Memo

SLP REV. 1 to SLP REV. 2

Date: April 25, 2016 **UBC Gage South** Re:

GAGE SOUTH EXCHANGE PHASE 1 - UNDERGROUND WORKS

CHECKED: CN

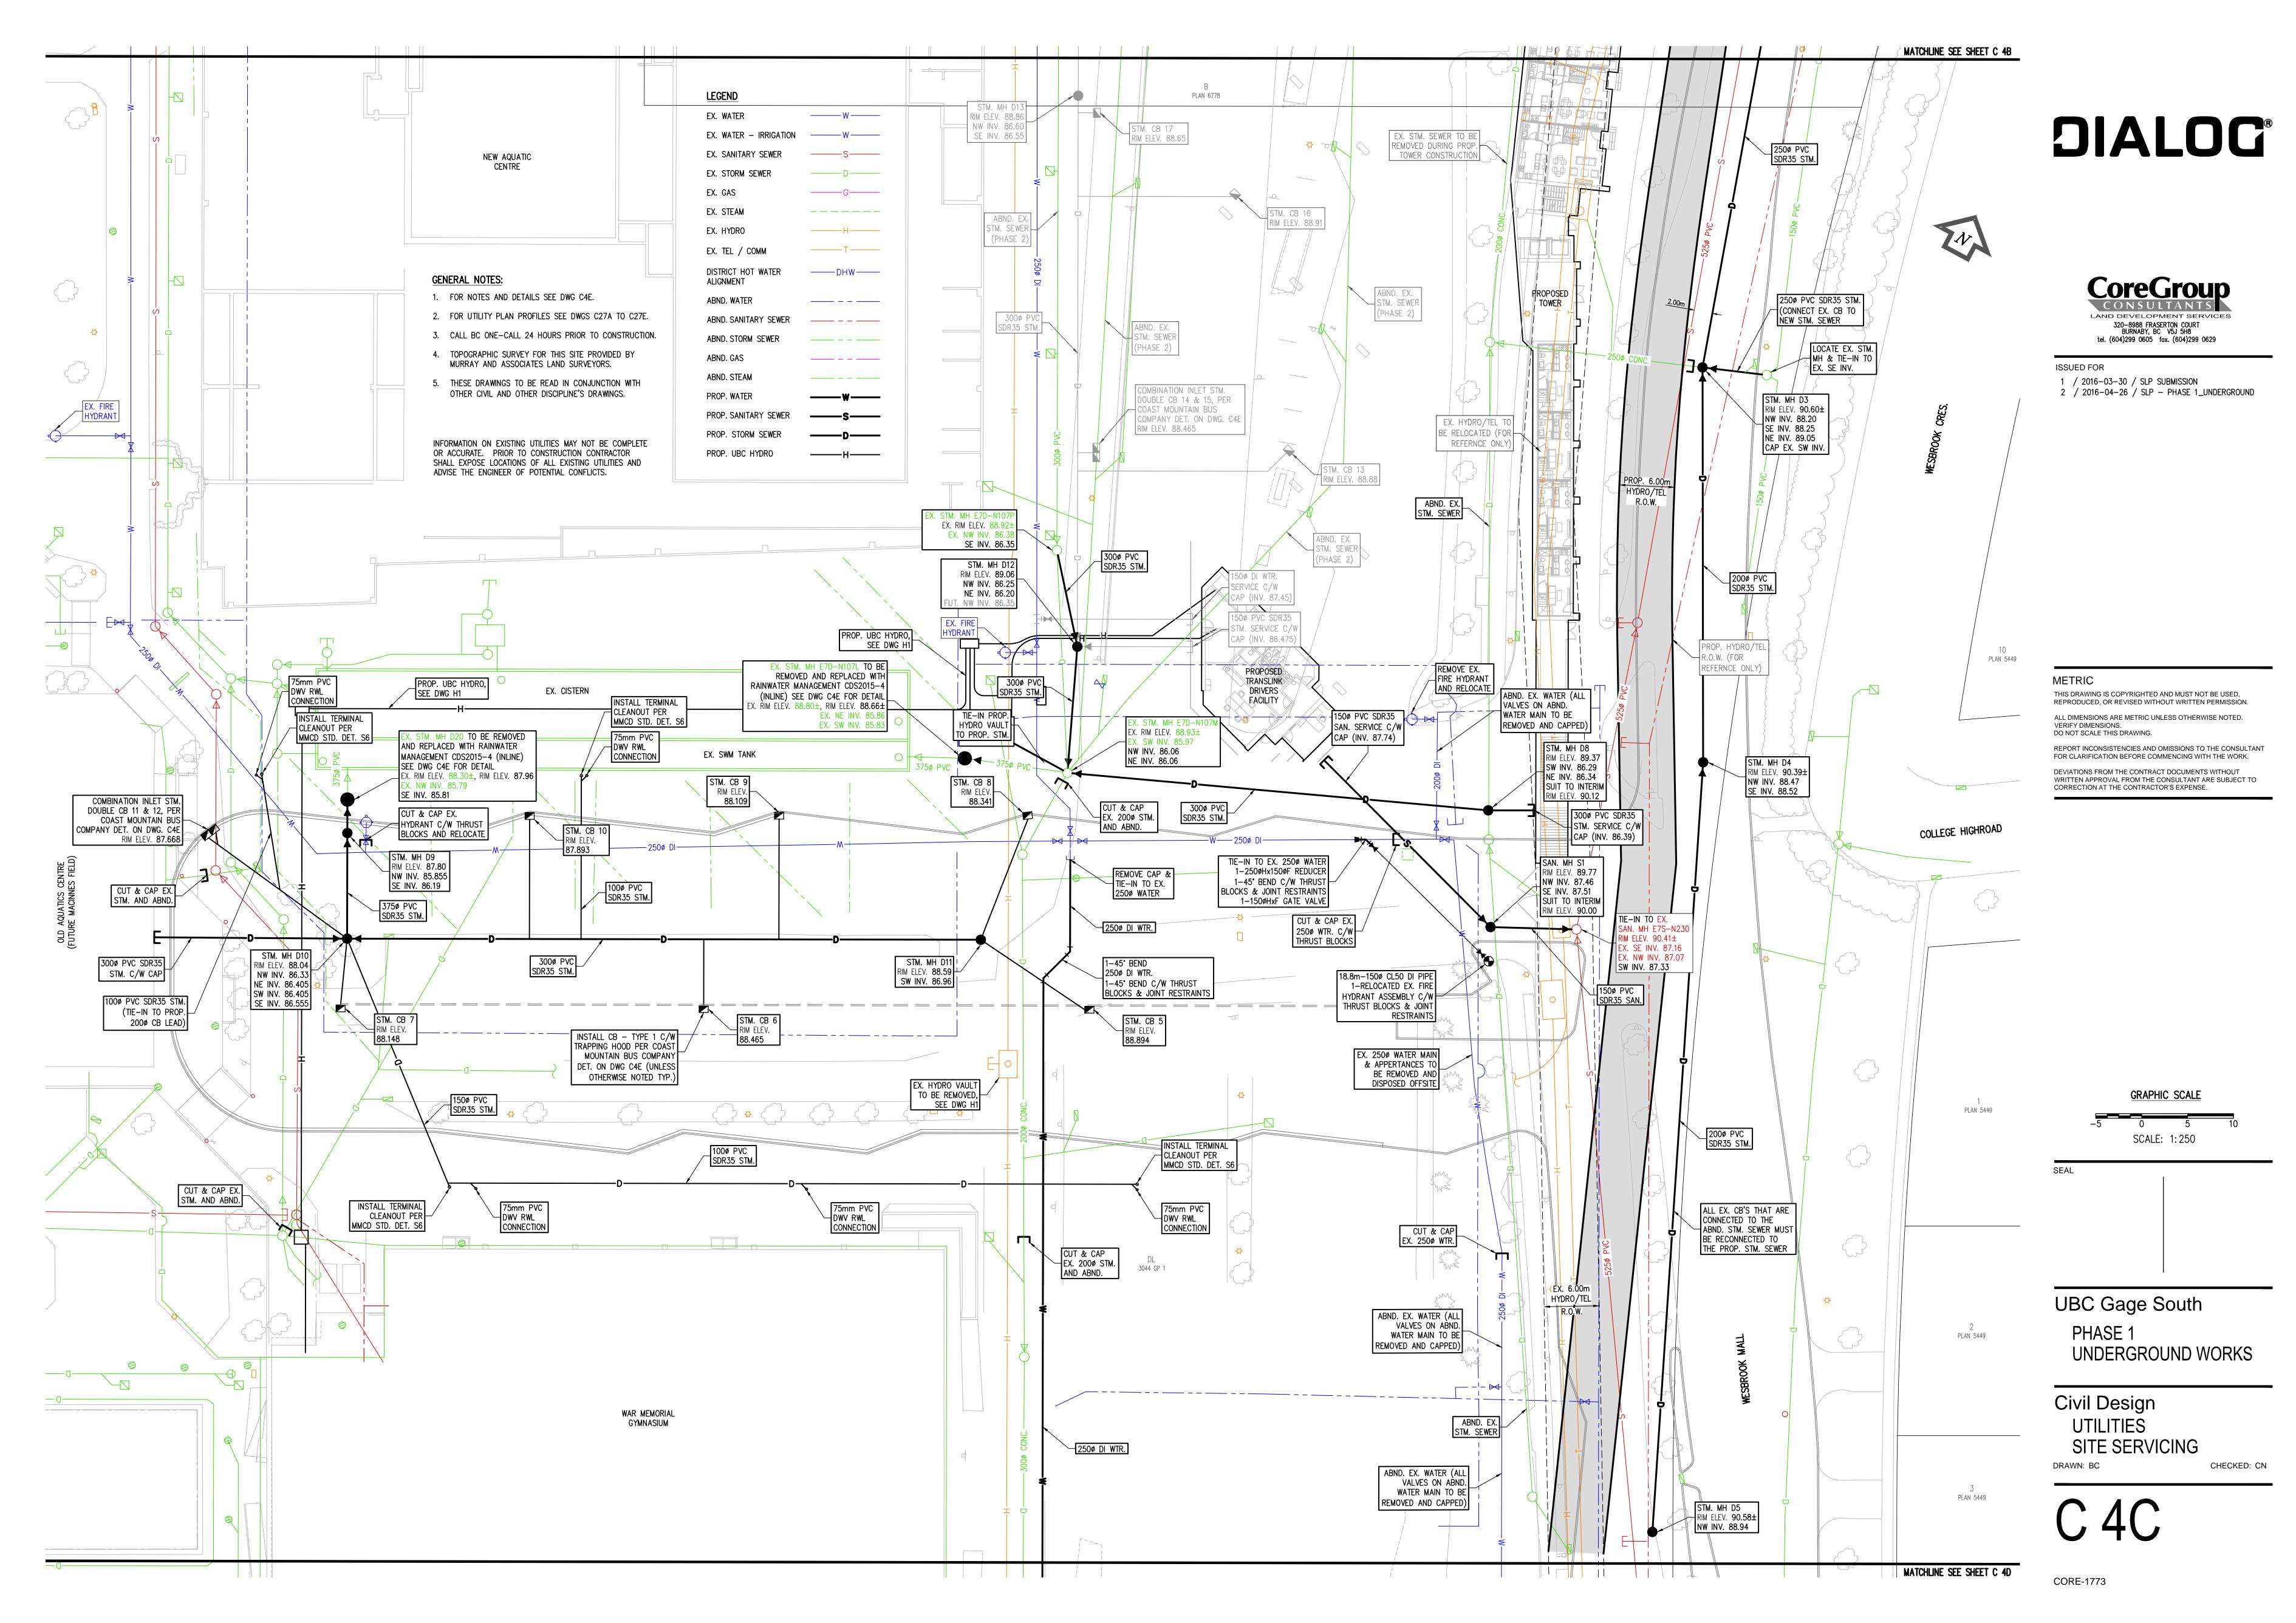
C4A - Utilities, Overall Site Servicing

- Water Connection and Hydrant Location Adjusted
- 2) Oil/TSS Removal Manhole Revised
- 3) Hydrant Removed
